APPLICATION FOR CERTIFICATE OF APPROPRIATENESS

Address 3408 E Broad St

Historic district Chimborazo Park

THE PARDUE HOUSE

CONTEXTUAL
 FRONT ELEVATION

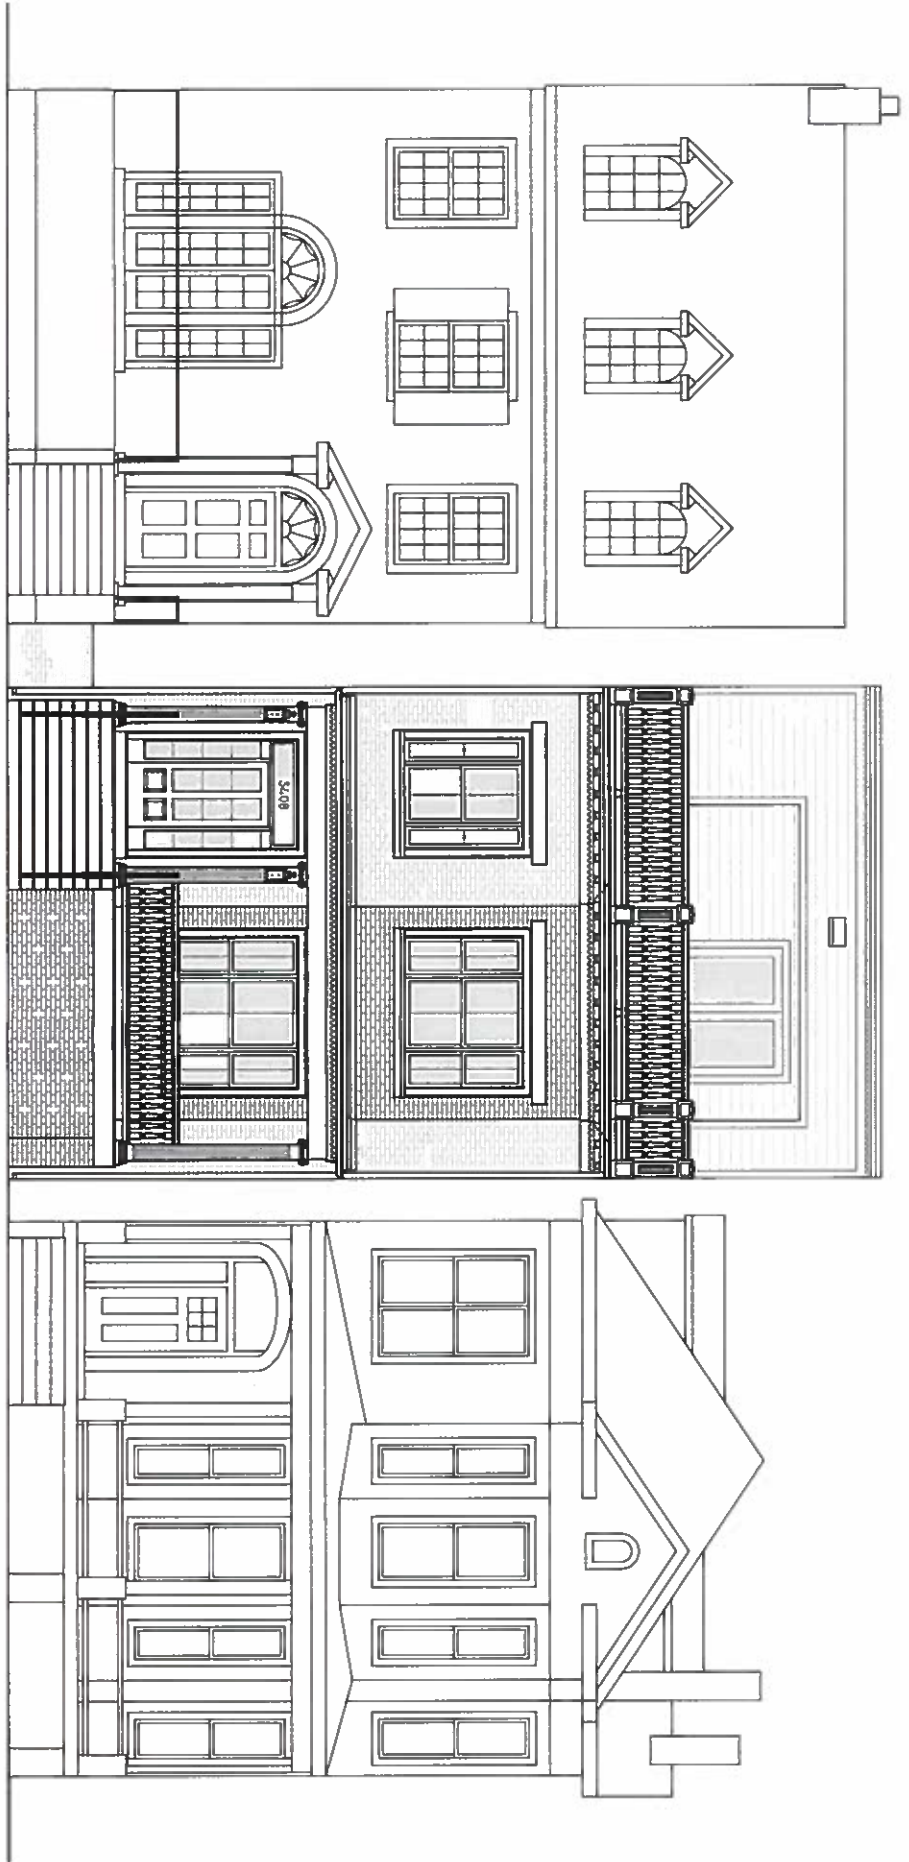
- 6) **Porch and Cornice Height compatibility with adjacent buildings** – It was requested that a contextual drawing be included to help illustrate the compatibility of these elements of our design. This is included in this packet.

FRONT & REAR
 EXTERIOR ELEVATIONS
A2.1

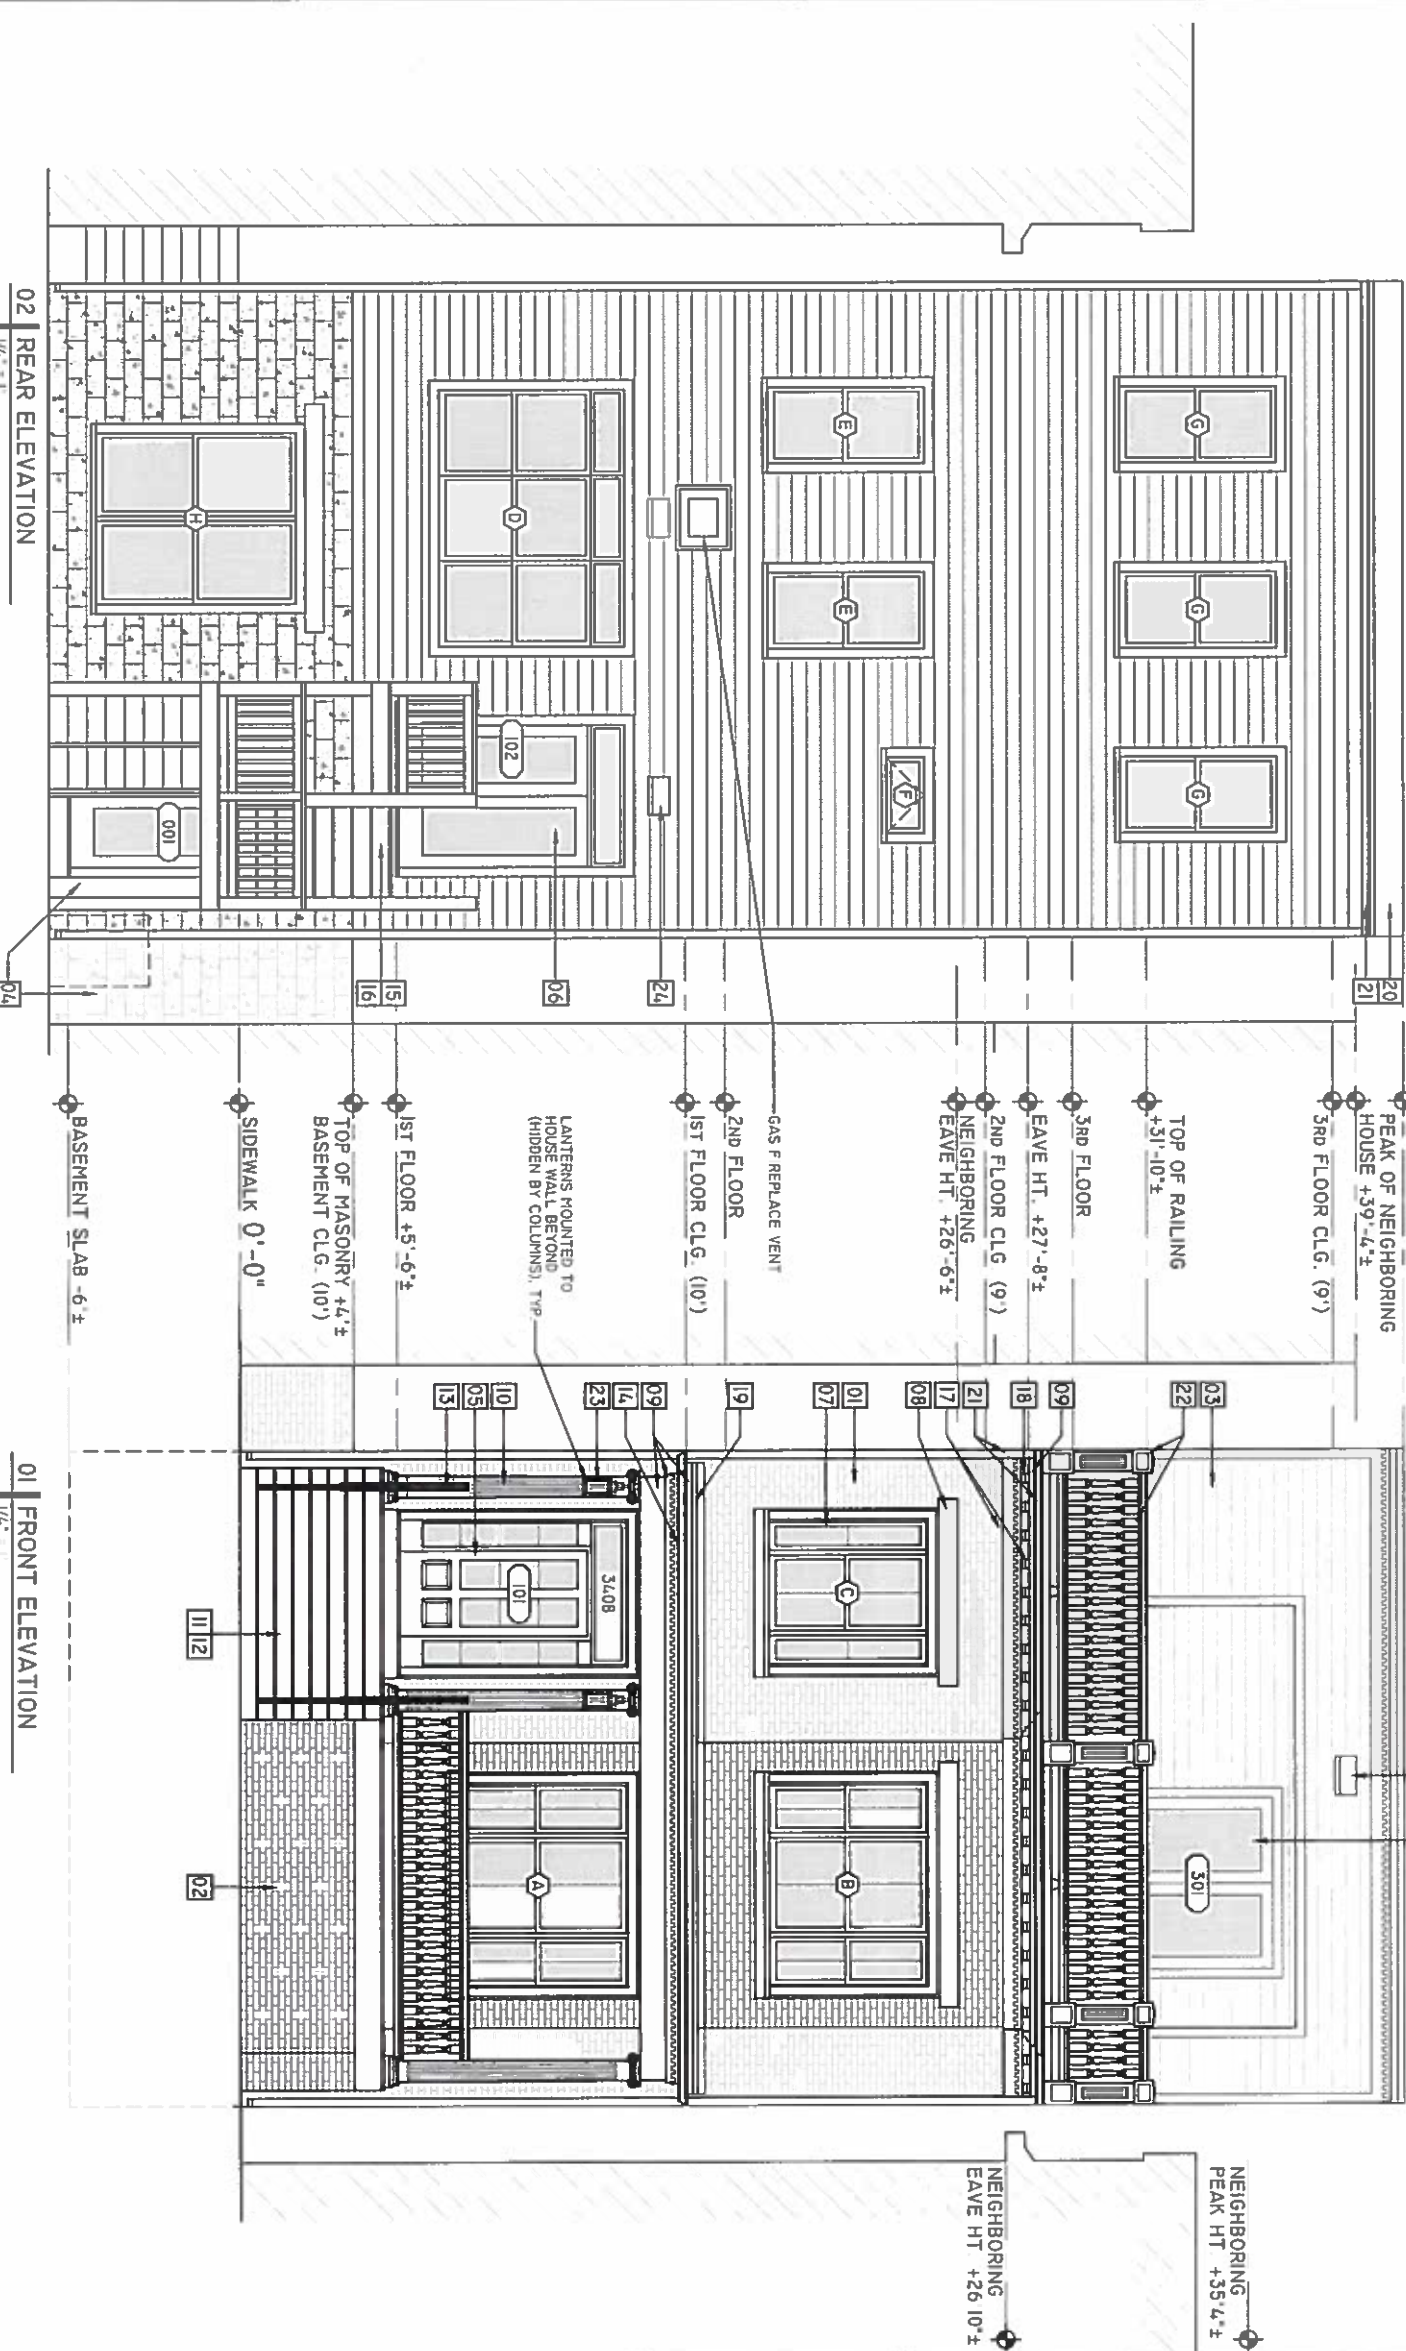
- 1) **Window Fenestration on Front** – The grouping of three windows on the front was discussed in the staff comments and at the meeting. However, this same window configuration was shown to be on the original home built on this lot. Therefore, we have left this fenestration on the front as we believe it is historically accurate and fits our personal tastes the most.

- 2) **Window Fenestration on Rear** – To note for the Commission, we changed the far-right window on the rear bedroom (third from ground in the rear) from a full-size window to a transom. After conceptual review, we realized we had drawn a full-size window in the middle of our owner's shower. Since it's incompatible to have a full-size window directly in the shower – and this window is on the rear of the home – we hope the commission will agree with this change. The second door that was previously located on the rear of the home, coming from the family room, has been replaced with three windows with transoms above.

RIGHT SIDE
EXTERIOR ELEVATION

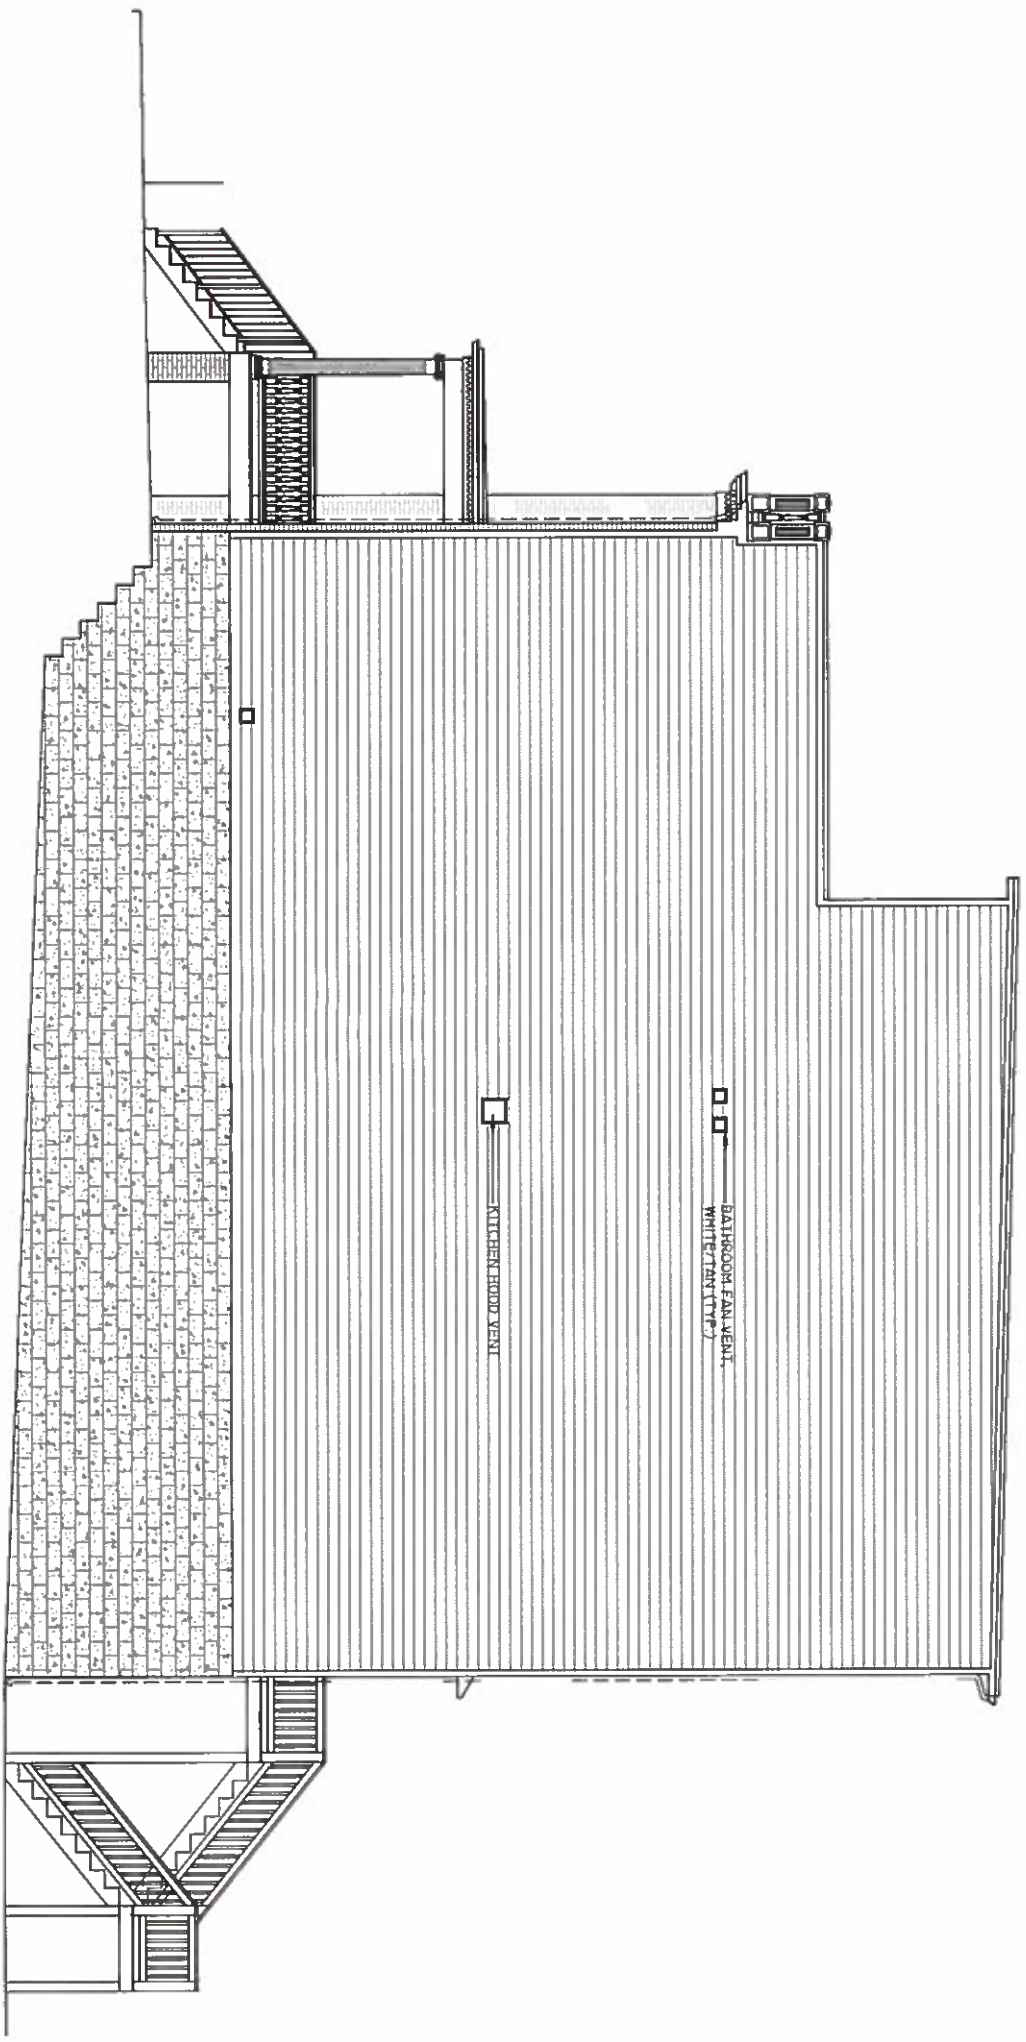
- 5) **Building Height** – The Staff commented the height of the building is taller than the adjacent buildings due to its third floor. The Commission recommended we move the third-floor roof back. We accommodated this request by moving it back four additional feet. This has a large impact on the visibility of this element as shown by the sightlines depicted on the right-side elevation drawing within this packet.
